City of Phoenix
PLANNING & DEVELOPMENT DEPARTMENT

Staff Report: Z-SP-12-17-8
December 20, 2017

Request To: C-2 SP SPVTABDO (Intermediate Commercial District with a Special Permit, South Phoenix Village and Target Area B Design Overlay District) (0.80 acres)

Proposed Use: Automobile retail sales and all underlying C-2 uses

SITE PLAN
09/25/17

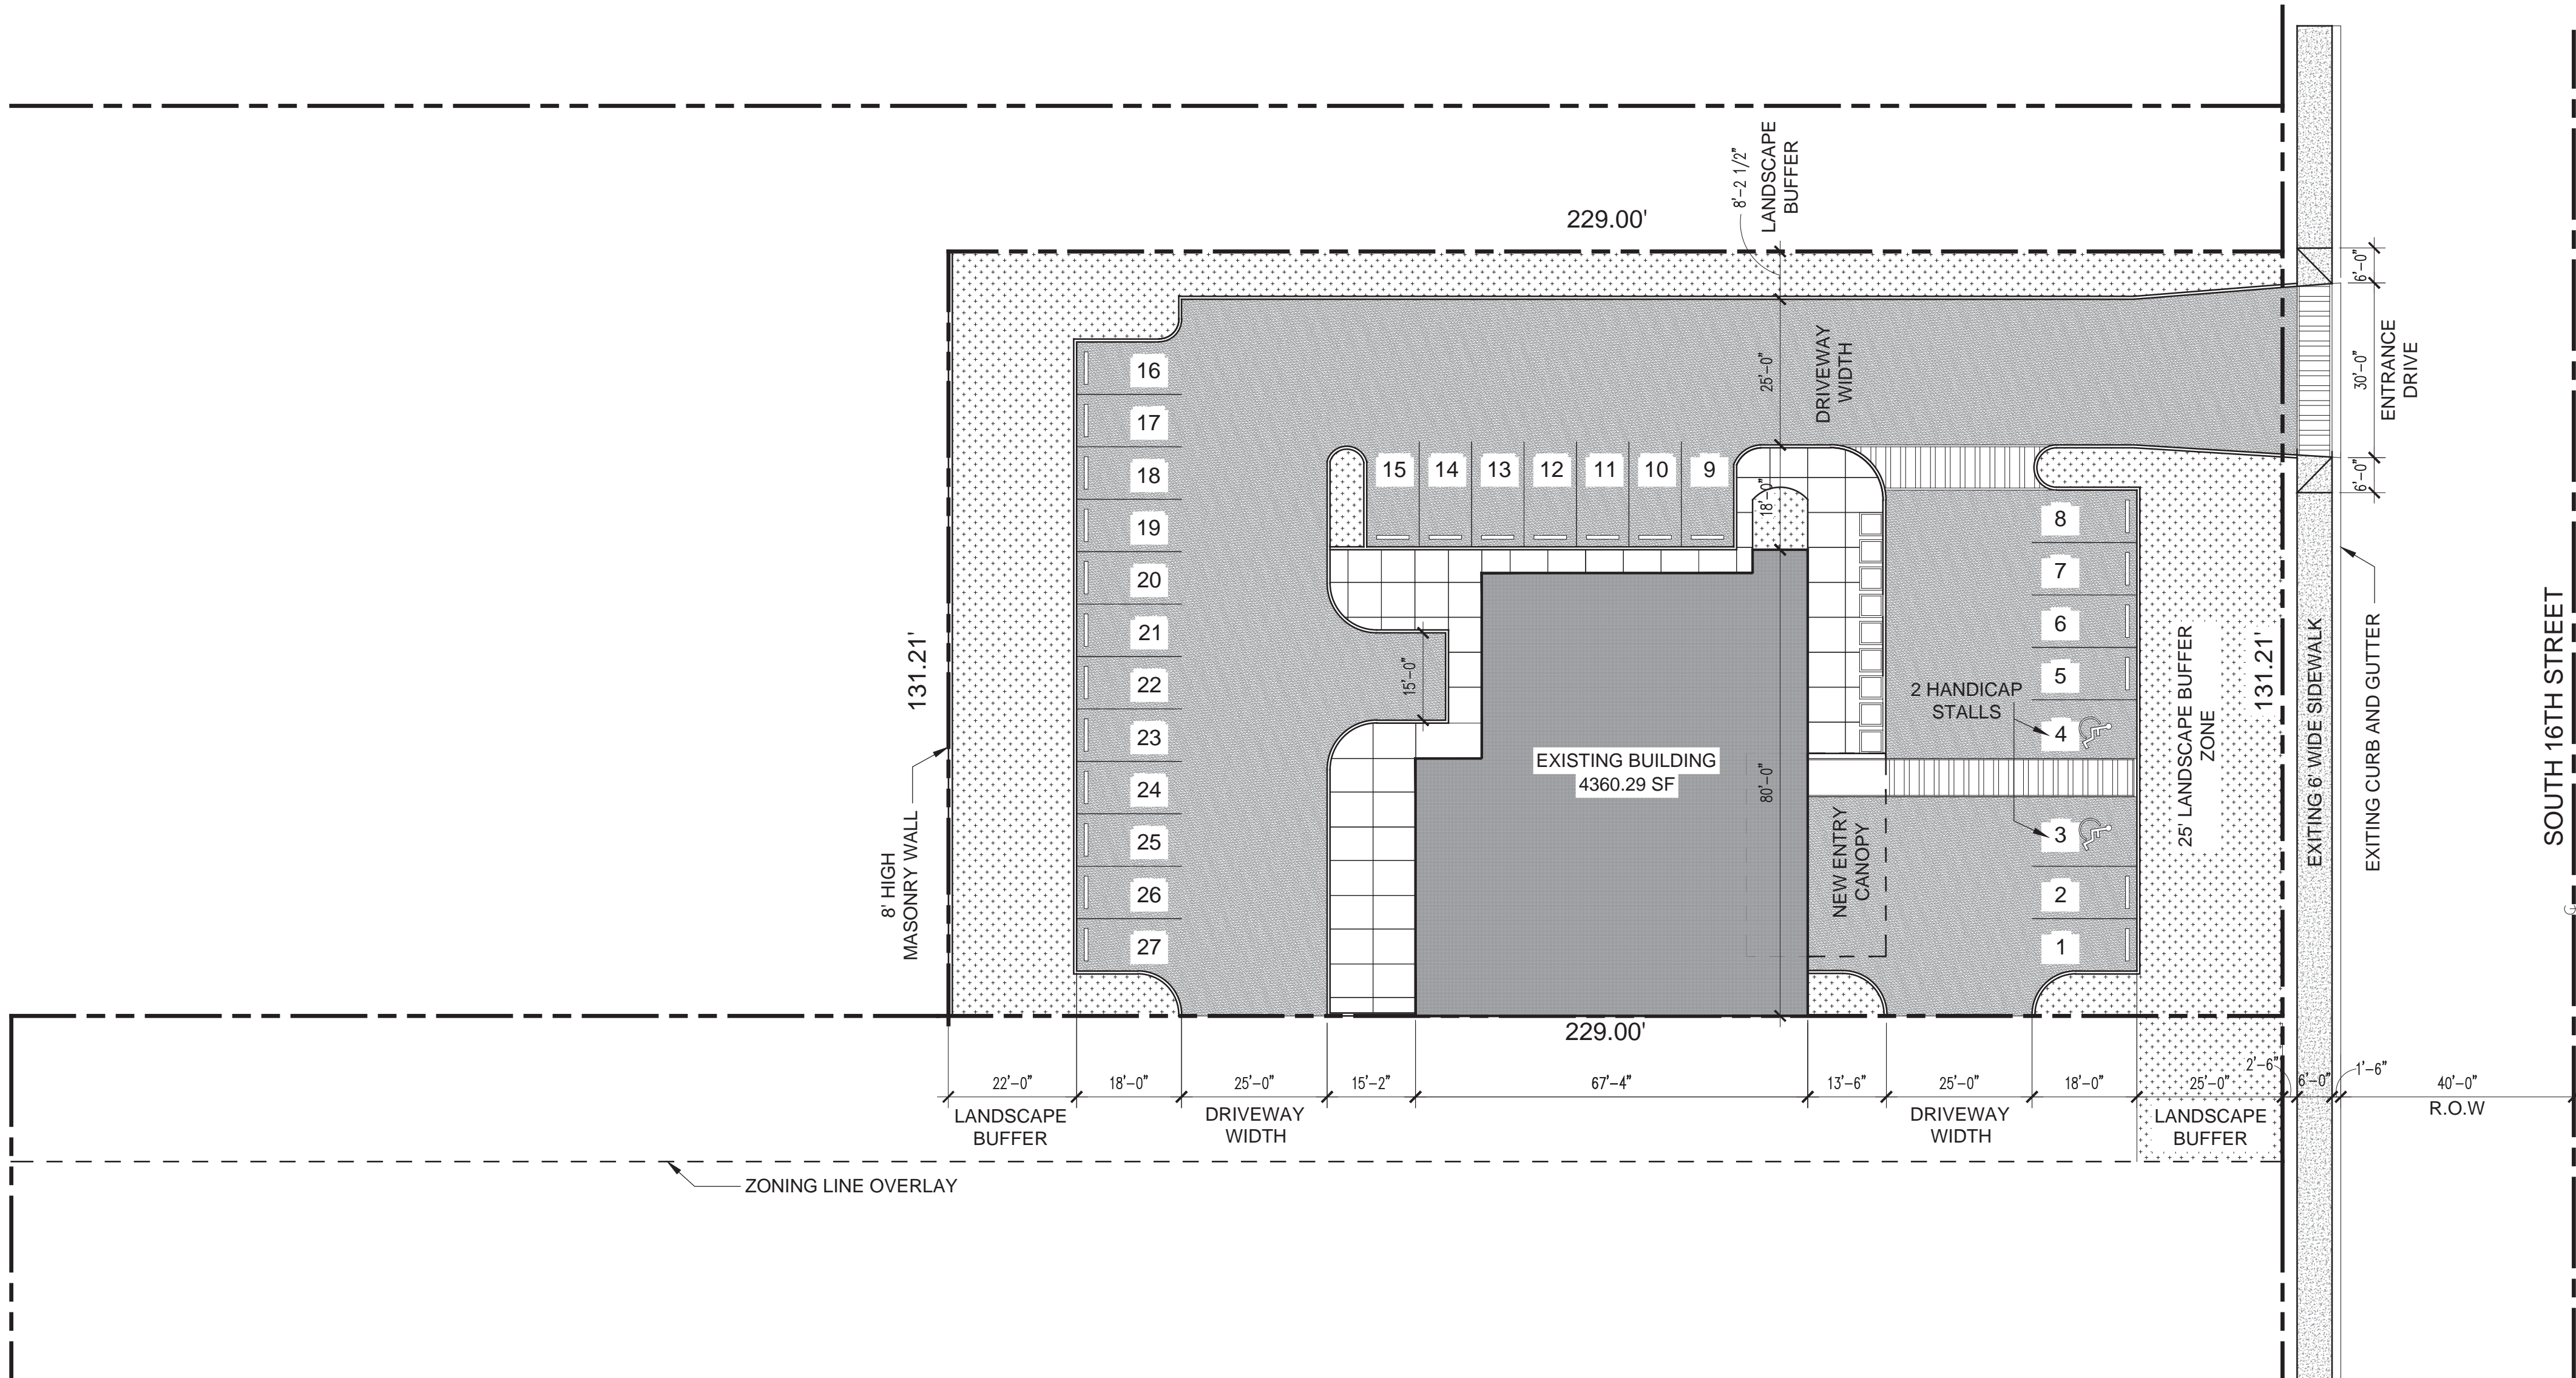
There will be no major changes to the overall footprint of the building; however, some interior and exterior improvements will occur, such as improvements to the landscaping, a new entrance driveway along 16th Street, an

expansion of parking lot paving, and newly painted parking spaces. The building will be improved and used as an automobile sales office on the subject site. The vehicles for sale will be displayed and repaired on the property to the south. The site plan notes two driveways connecting both parcels which will allow them to function together as one site when necessary.

The site has a chain link fence topped with barbed wire along the southern boundary of the site. The City of Phoenix Zoning Ordinance, Chapter 7, Section 703, prohibits the use of chain link fencing on a non-residential development where visible from a public street or residential zoning districts. In addition, the Zoning Ordinance prohibits the use of fences topped with barbed wire when visible from a public street or residential zoning districts. Subsequently, the existing chain link fence and barbed wire must be removed or relocated to not be visible from the public rights-of-way or residential zoning districts. Should the two driveways connecting the two parcels be gated, a wrought-iron gate would be required. This requirement is addressed in Stipulation No. 1.

12. The Street Transportation Department has indicated that the developer shall provide a 10-foot sidewalk easement for the west half of 16th Street and that the developer shall provide a 30' P1255-1 driveway on 16th Street. Further, Street Transportation has indicated that the developer shall construct all streets within and adjacent to the development with paving, curb, gutter, sidewalk, curb ramps, driveways, streetlights, median islands, landscaping and other incidentals as per plans approved by the City. All improvements shall comply with all ADA accessibility standards. This is

1. If a gate or gates are utilized for drive aisles between the C-2 SP and A-2 portions of the site, the gate(s) shall be wrought iron, as approved by the Planning and Development Department.

3. The developer shall provide a 10-foot sidewalk easement for the west half of 16th Street, as approved by the Planning and Development Department.
4. The developer shall provide a 30-foot P1255-1 driveway on 16th Street, as approved by the Planning and Development Department.

RD.2
ELEVATIONS
09/25/17

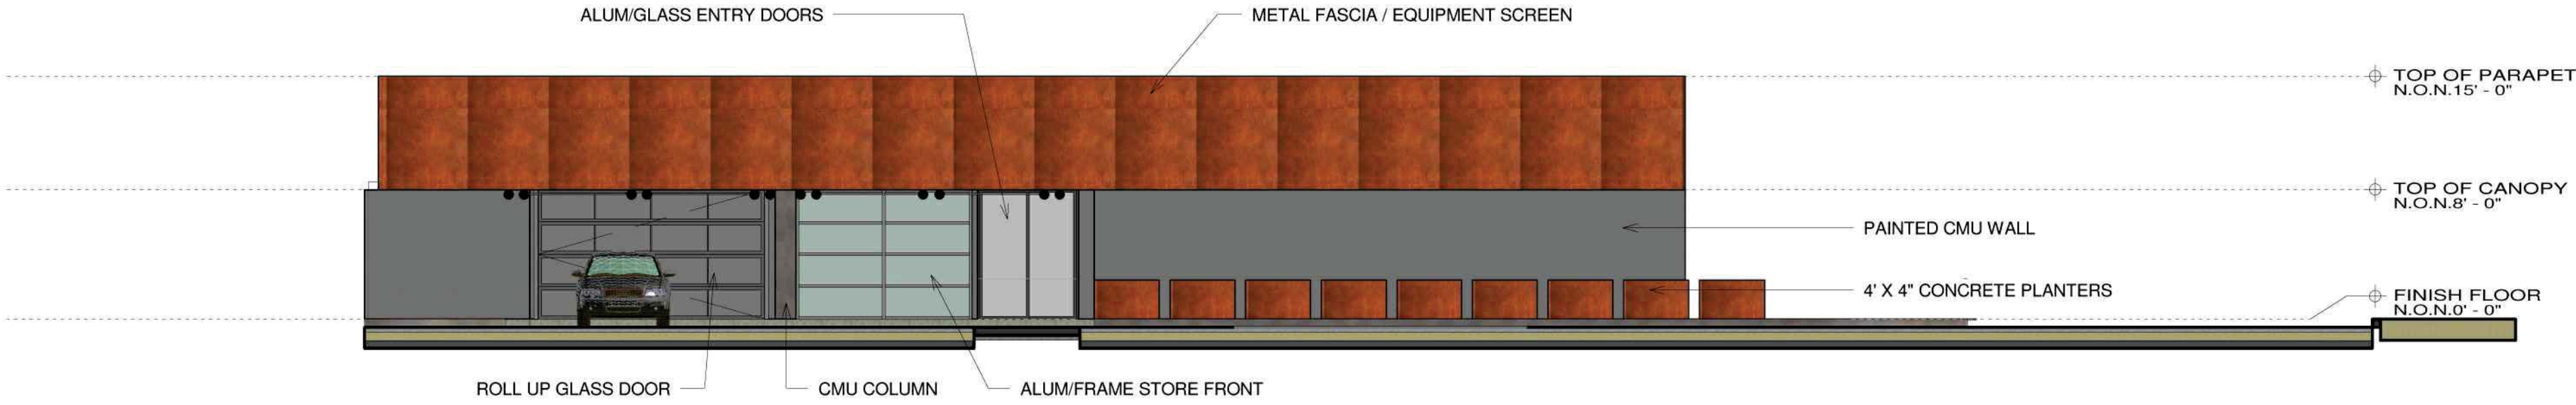
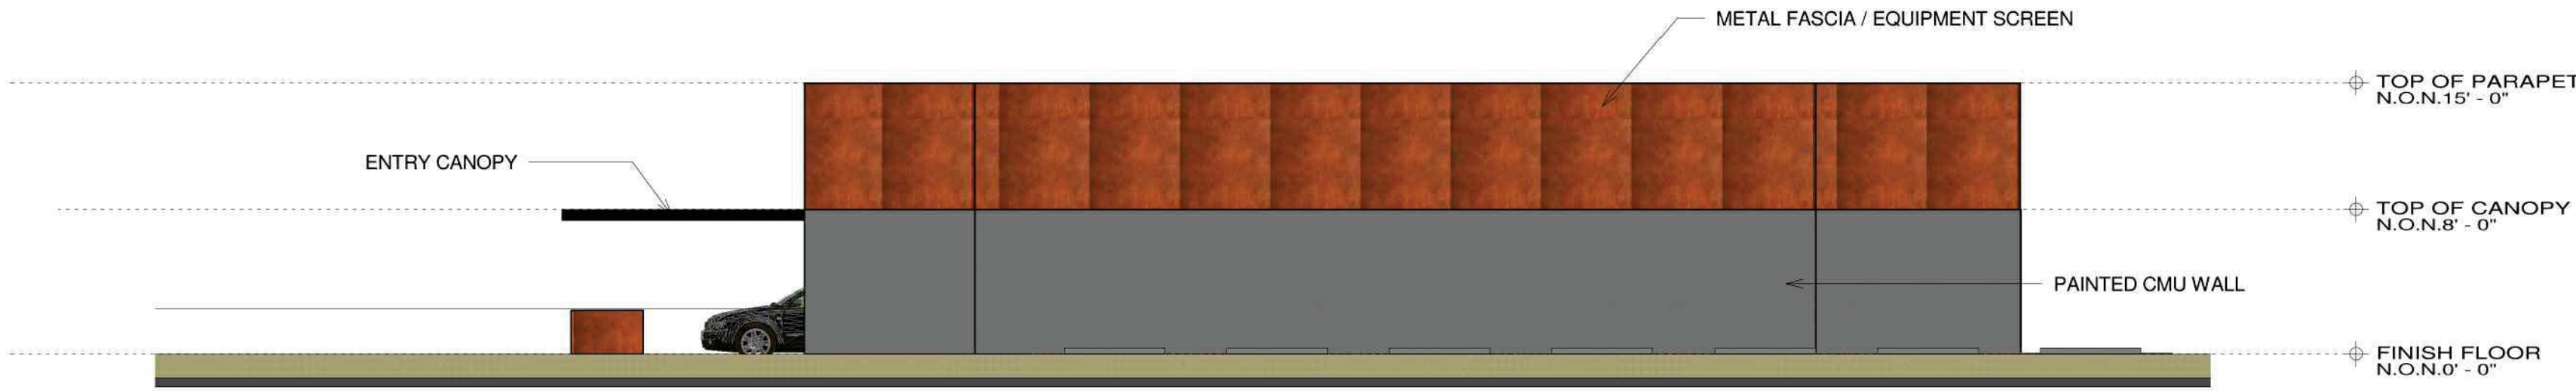
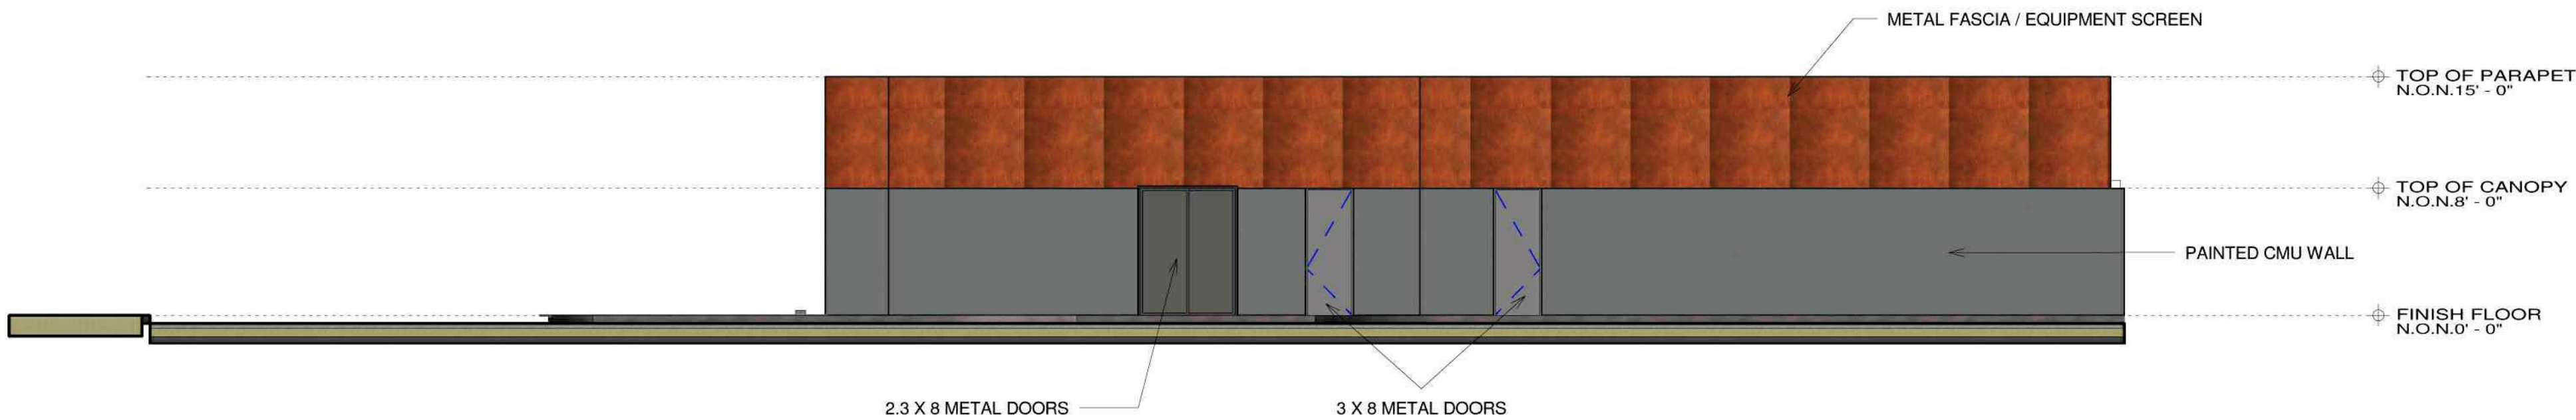
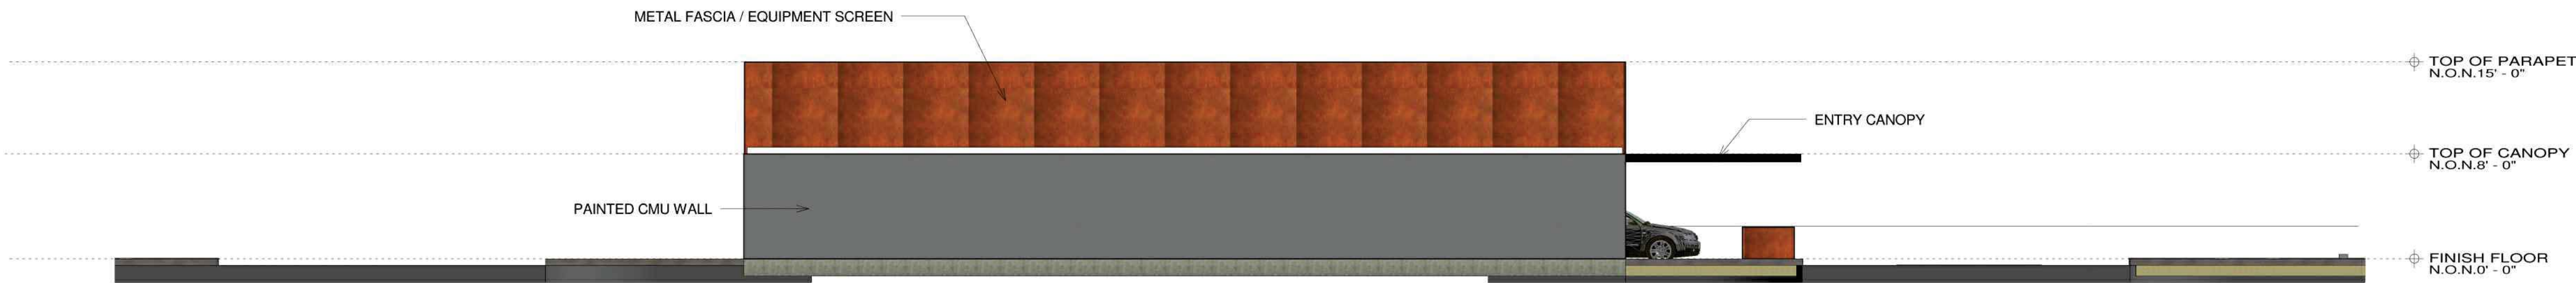
The elevation plans depict exterior improvements to the building such as a roll up glass door, a metal fascia equipment screen around the face of the building, and four-foot by four-foot concrete planters along the front of the building.
